September 14, 1988
GEN-1270

Subject: Control No. 019643; Submittal of an Expanded Appendix 5.0 to General Atomics' Application for License to Distribute Irradiated Topaz

APPENDIX 5.0

Assay of Large Samples of Gemstones Using High Resolution Semiconductor Detector

Fig. 1. Sketch roughly to scale showing dome shaped holder. This surface of revolution accommodates about 50 1 gram stones. For this holder the detector has about 44% of the sensitivity for a single stone placed at the usual (7.5 mm) position. Measured sensitivities are shown.

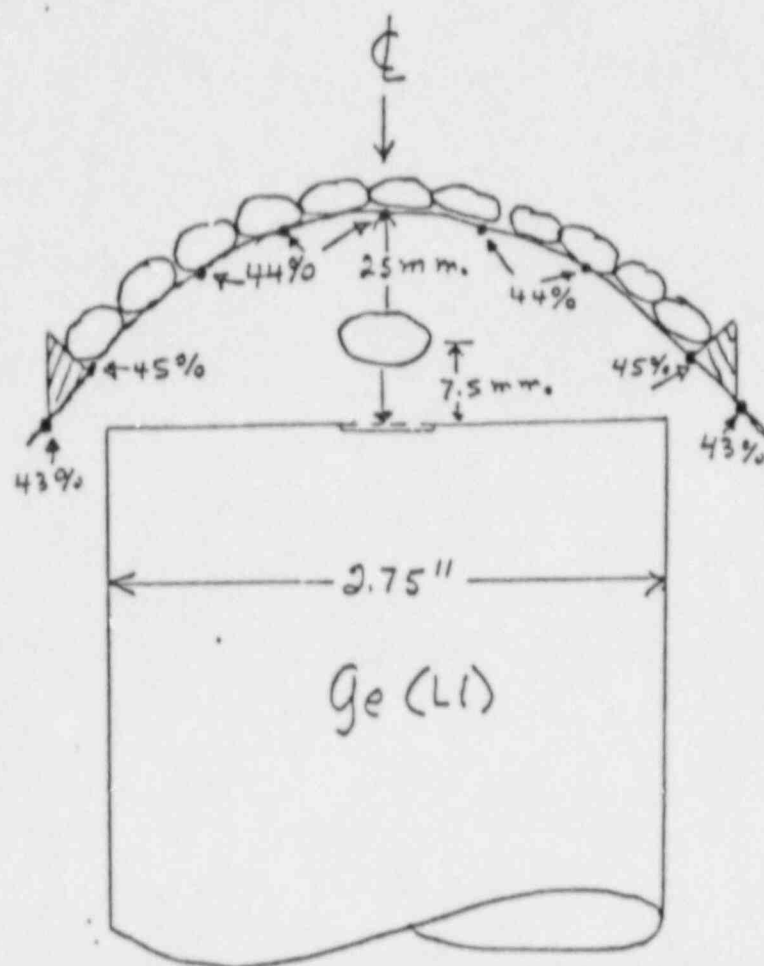
The design of a holder for the assay of a large number of gemstones in Step K1 (Figure 1 of Application) (eg., ~50 1-gram stones) is based on experimental measurements made with a specially assembled source containing approximately 0.08 μ Ci Cs-137 (662 keV) and 0.13 μ Ci Co-60 (1173, 1333 keV). The source holder for these measurements was a small polyethylene cap with inside diameter of about 8 mm and about one-half millimeter thickness between the source and the gemstone holder. A survey was made in four quadrants and at various heights to arrive at the curvature shown in Figure 1.

The relative sensitivity as a function of position is 44% of the sensitivity for a single stone placed in the usual location used for measurements on a single stone. The value (44%) is an average at each location of the sensitivities for the gamma rays from cesium and cobalt.
